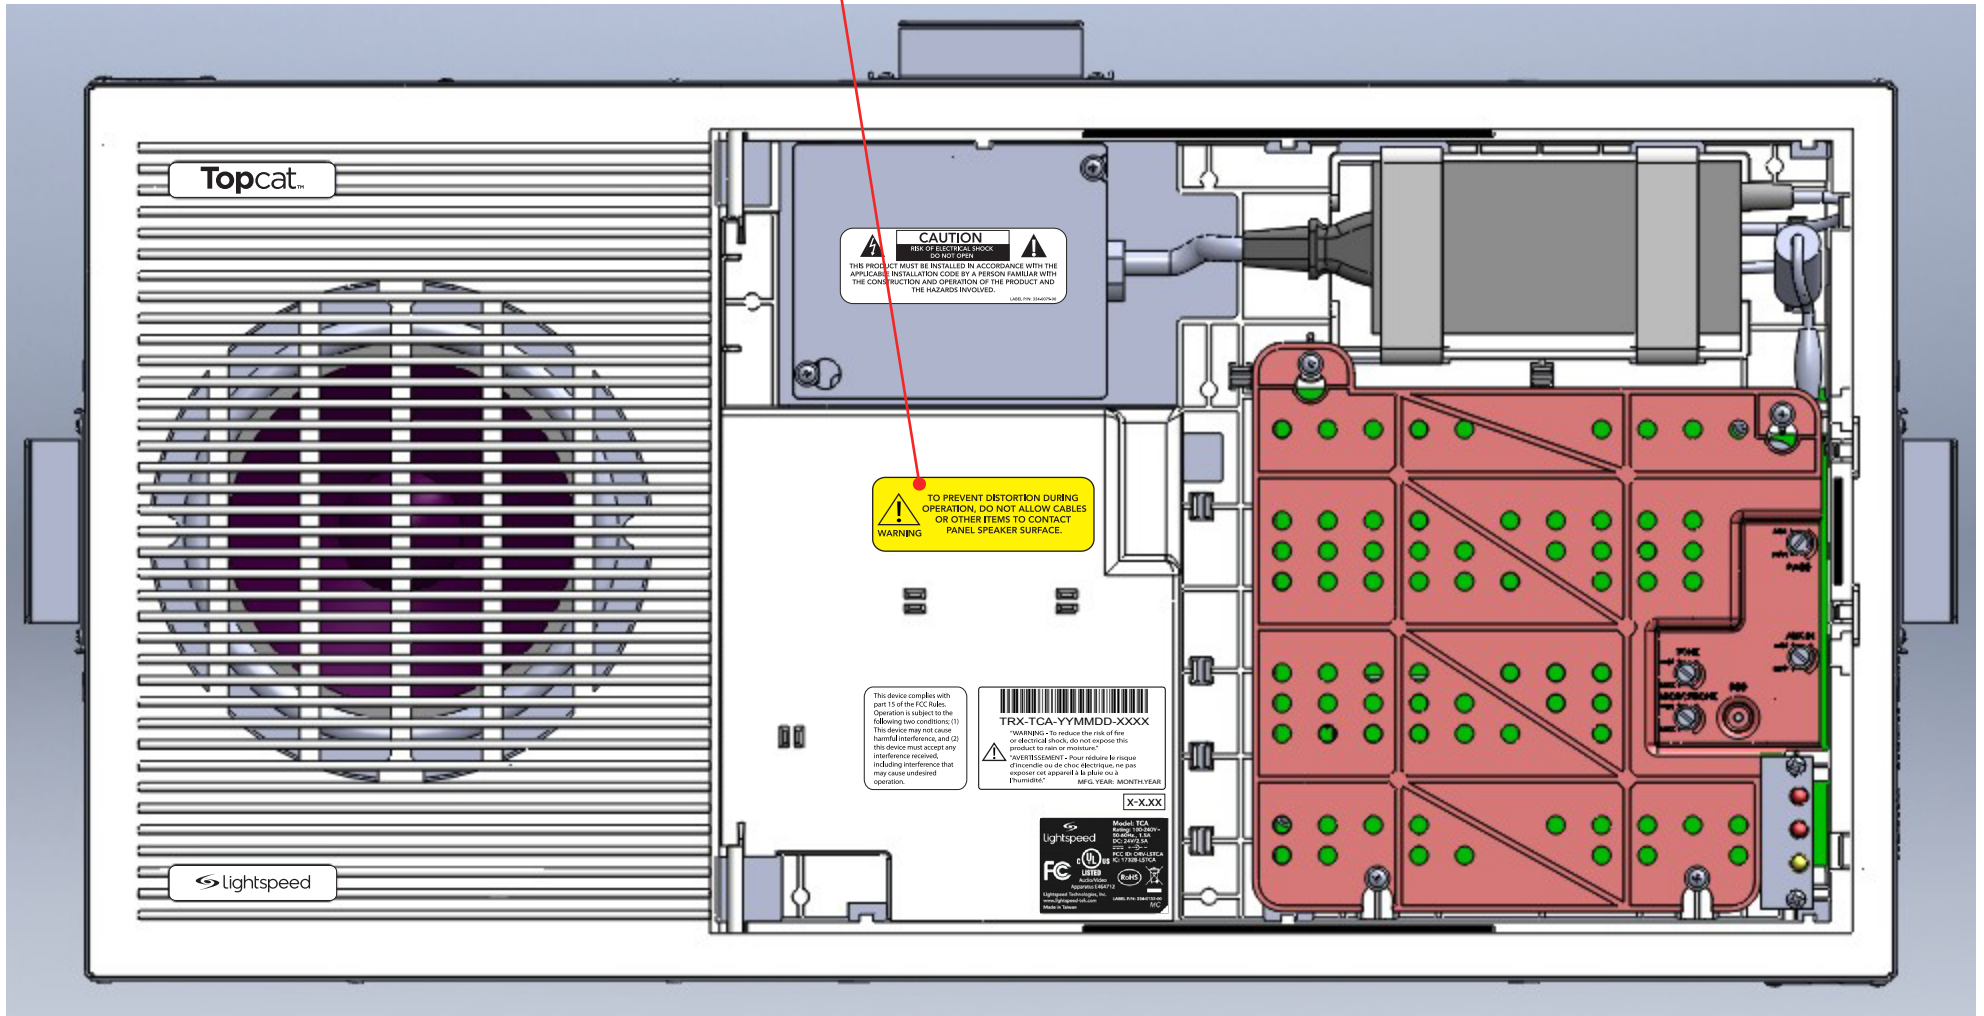
THE CABLE INSTALL LABEL (YELLOW) SHOULD BE NEAR THE WIRING FOR THE NXT PANEL.  
WE'VE FOUND THAT INSTALLERS NEED TO ENSURE THE WIRE DOES NOT TOUCH THE PANEL.  
LOCATING IT ANYWHERE ELSE BUT BESIDE THE WIRING WOULD DEFEAT THE PURPOSE.

THE NAMEPLATE ALREADY HAS A CUTOUT INSIDE - WE SHOULD USE IT.  
THE SERIAL NUMBER AND SW REVISION LABEL SHOULD BE PLACED ABOVE THE NAMEPLATE.  
THE FCC PART 15 (FOR PRODUCTION ONLY - NOT PILOT) SHOULD BE PLACED IN THE AREA.
